DEVELOPMENT APPLICATION ASSESSMENT REPORT

Application Number:	DA2024/1160
----------------------------	-------------

Responsible Officer:	Brittany Harrison
Land to be developed (Address):	Lot 72 DP 11462, 19 Dress Circle Road AVALON BEACH NSW 2107
Proposed Development:	Alterations and additions to a dwelling house including a detached garage and home office
Zoning:	C4 Environmental Living
Development Permissible:	Yes
Existing Use Rights:	No
Consent Authority:	Northern Beaches Council
Land and Environment Court Action:	No
Applicant:	Mathew Charles Phillip Hayward

Figure 1: North-west Elevation - Red shading demonstrates encroachment.

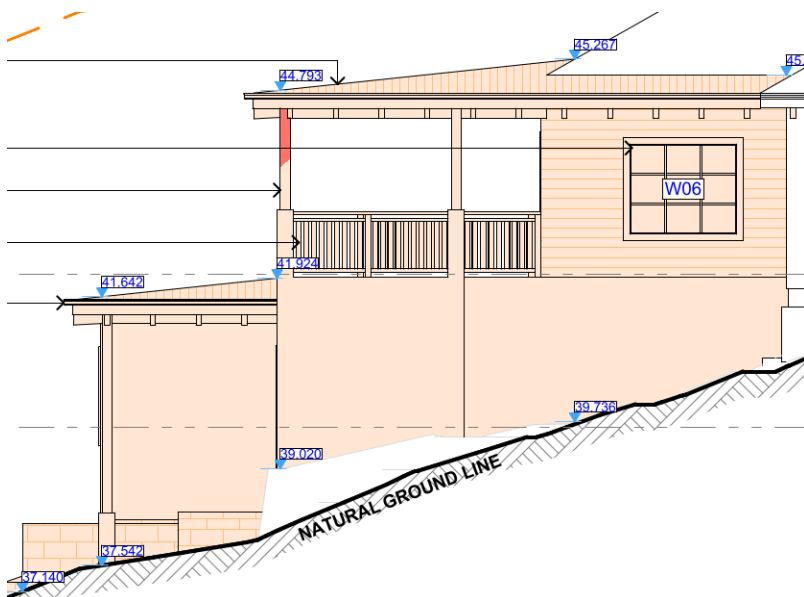
Clause D1.11 Building Envelope requires development to be sited within a 3.5m building envelope to ensure the bulk and scale of the built form is minimised.

The proposed works consist of a minor envelope breach to the north-west and is limited to a section of a pergola post (Figure 1). It is noted that the bulk of the dwelling, studio and garage comply with the required envelope.
